# AutoGyro Certification Ltd    Service Bulletin (Permit)

<b>Title: Inspection of Rotor head</b>		<b>Release date 07.10.2022</b>
<b>SB-147 Iss1</b>	<b>Related documents</b> Modification: CCAR No.: None	<b>Compliance Category:</b>  <b>OPTIONAL</b> <del>or</del> <b>RECOMMENDED</b> <del>or</del> <b>MANDATORY</b>
<b>Applicability</b>		
<b>Aircraft type &amp; model:</b> All Cavalon and Calidus with Rotor head III	<b>Aircraft serial Nos. affected:</b> All Cavalon and Calidus with Rotor head III	
The maintenance manual to be referenced is this stated or subsequent issue.		None
<p>This form is the response from AutoGyro Certification Ltd either against a problem found in the product in service requiring a containment or rectification action, or as service information for aircraft modification incorporation. For help, contact RotorSport on 44(0)1588 505060, or email <a href="mailto:compliance@rotorsport.org">compliance@rotorsport.org</a>.</p> <p>The technical content of this document is approved under the authority of the UK CAA Design Organisation Approval Ref: <b>DAI/9917/06</b></p>

The purpose of this SB is to highlight the need for effective pre-flight and service inspection of the we

**Rotorhead III**

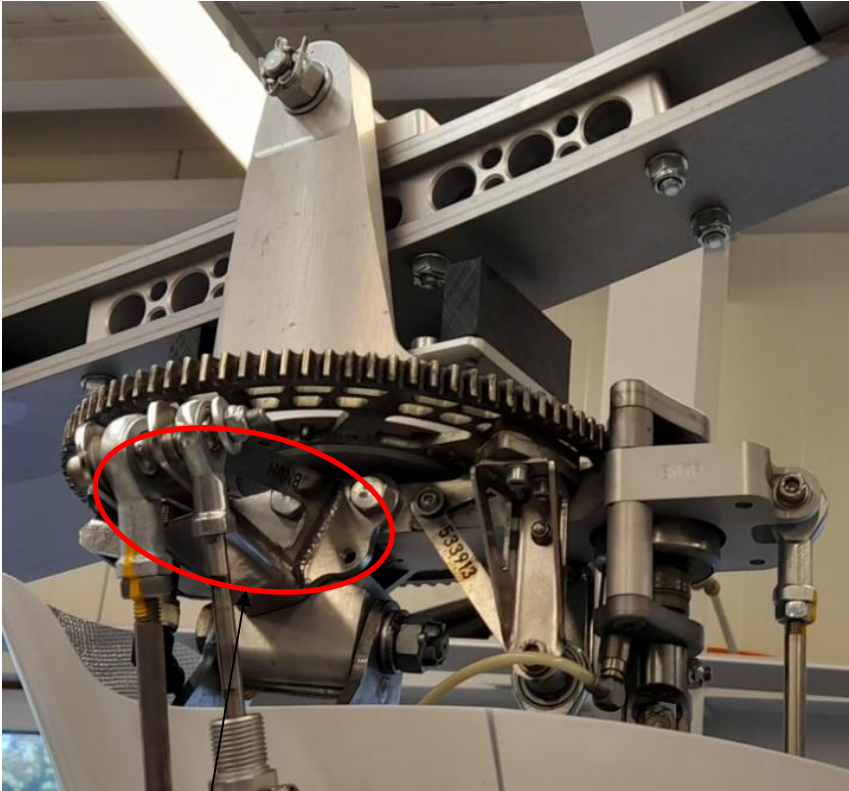
Pre-flight inspection requires a thorough review of the rotorhead. Pilot/operators are reminded that this includes the welded connection between the side plates and roll link bracket shown below. This area is open for easy inspection. If a crack is found, the part is to be replaced in accordance with normal maintenance procedures.

Rotorhead III bridge linkage, welded,  
PN 43689  
Inspect this area, both sides of the  
bracket.

External weld with crack:

This area is readily inspected during pre-flight inspection

There are two generations of the Rotor head III Rotor head bridge roll linkage assemblies. The second generation is welded on the inside upper end of the bracket, see photo, and was released in 2019. Only this later generation is available, and is fully interchangeable with the earlier version.

Note: these assemblies are stamped with the size (21.5 and 22.5). If replacing, ensure that the correct size is fitted!
